SEWAGE DISPOSAL SYSTEM

MARYLAND STATE DEPARTMENT OF HEALTH

SUBDIVISION Fox Pause ROAD 6700 Guilford Road LOT 11

LOT 11 FOXPAUSE SUBDIVISION
 6700 GUILFORD RD, CLARKSVILLE, MD
 SECTION 2 SCALE 1"=100'
 ROAD APRON INSTALLED SHARE
 WITH LOT 12

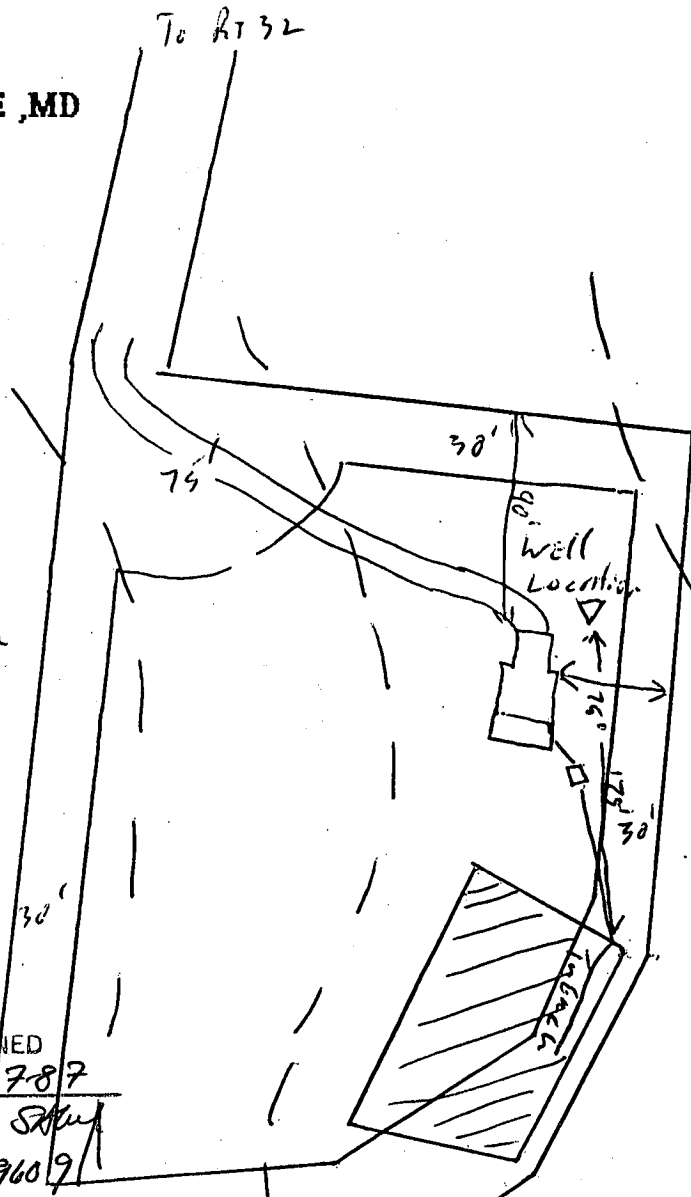
*1-7-87
 elevator
 site plan ok.
 SJK*

*160/BR
 3.5-8.5
 4BR
 128 LF of Trench for 4BR
 w/o disposal*

*Called to confirm
 # next corner 60'
 owner/disposes
 away to change*

*Count this part
 in the trench*

FIRST FLOOR	<u>436</u> ✓
BASEMENT	<u>428</u> ✓
INV ELEV HOUSE	<u>423.20</u> ✓ <i>433.20</i>
INV ELEV TANK	<u>433</u> ✓
EXIST ELEV	<u>435</u> ✓
INV ELEV FR TANK	<u>432.75</u> ✓
INV TO TRENCH	<u>432</u> <i>431.5</i> ✓
EXIST ELEV	<u>435</u> ✓
